PROJECT REVIEW

1. CASE 26.005, 126 BENEVOLENT STREET, Vacant Lot (POWER-COOKE)

September 21, 2026

Per the requirements of the Historic District Commission's Standards and Guidelines for Final Review, the following is a summary of design changes made since Conceptual Design Approval was granted on March 23, 2026.

4 WEST - CARRIAGE HOUSE
1/8" = 1'-0"

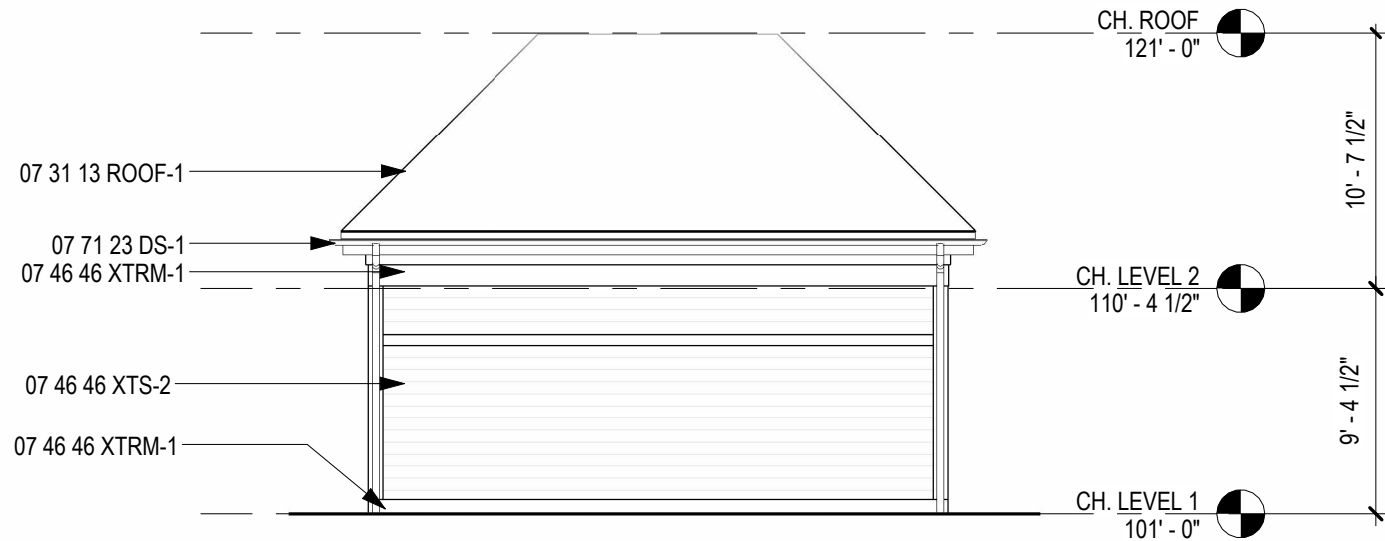
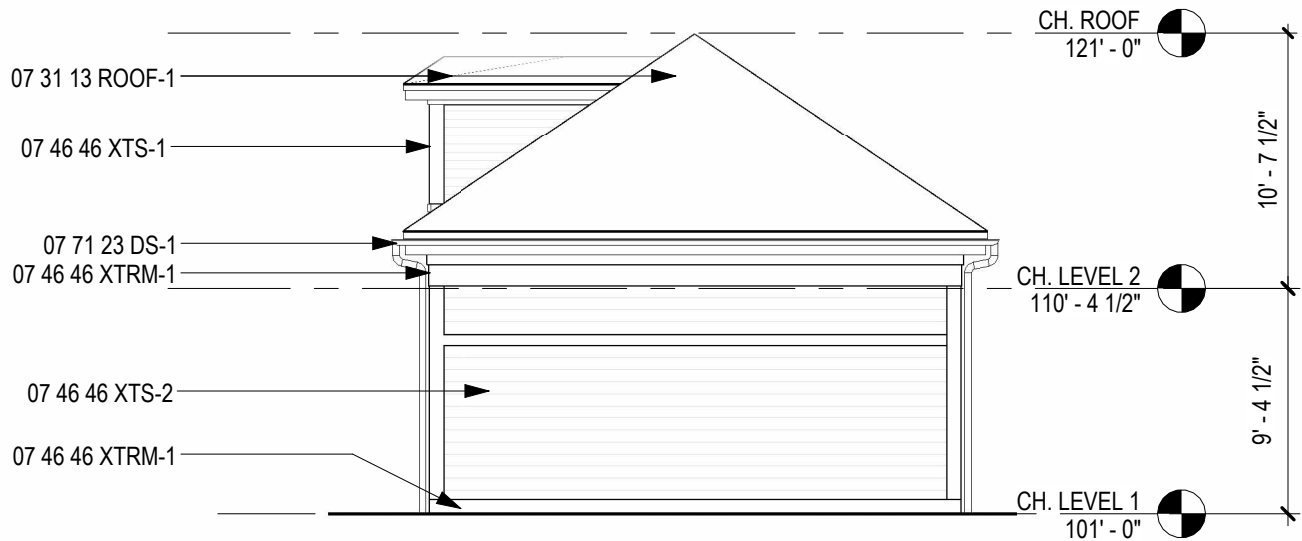
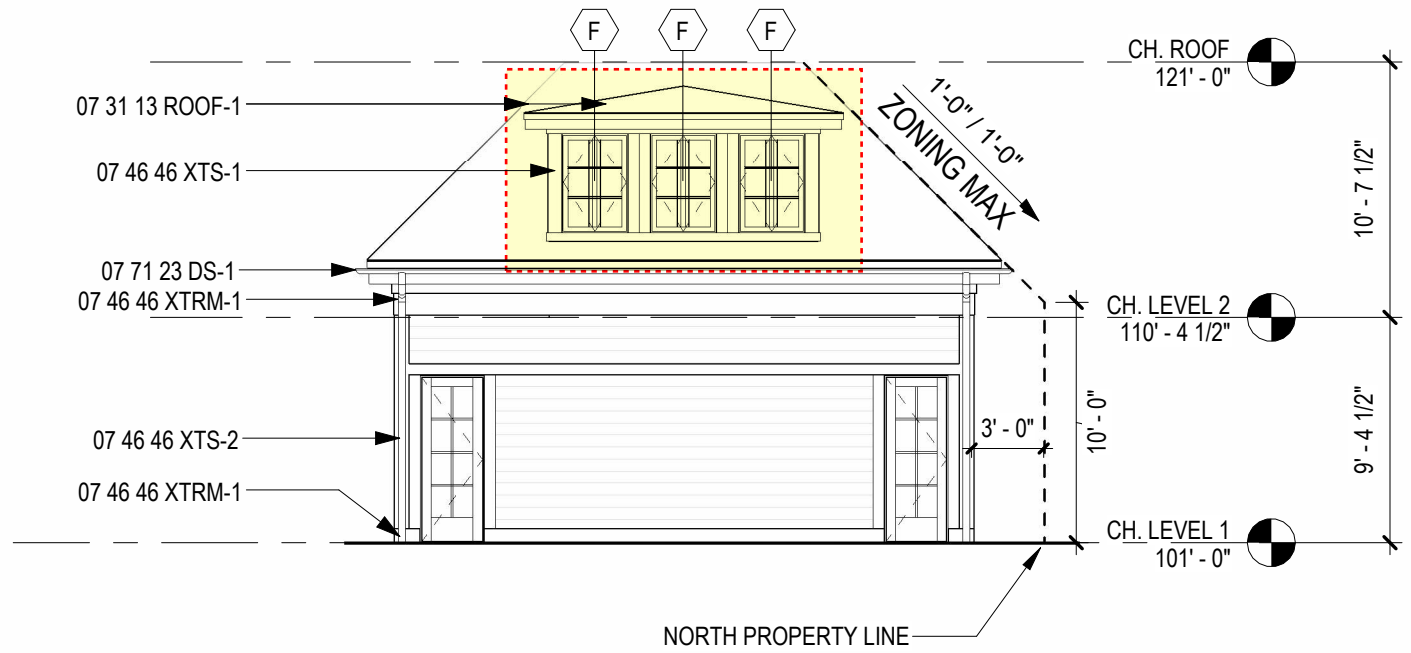
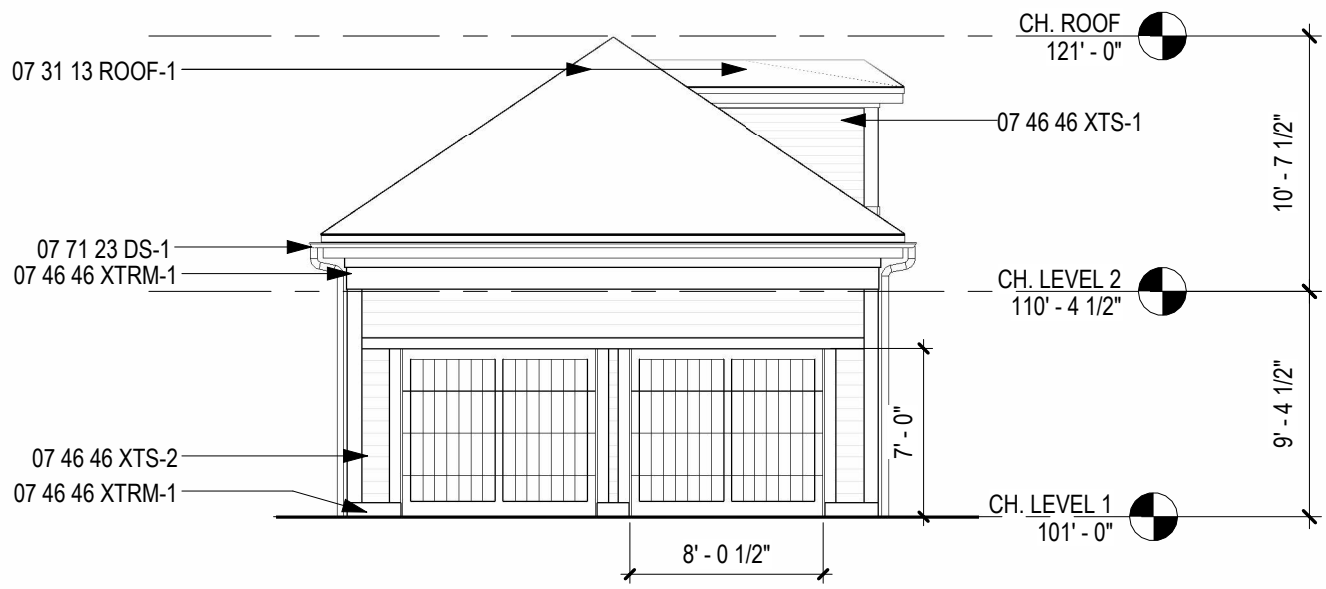
10. The quantity of windows at the carriage house dormer have been reduced from four to three; and,
- Revised plans have been submitted.
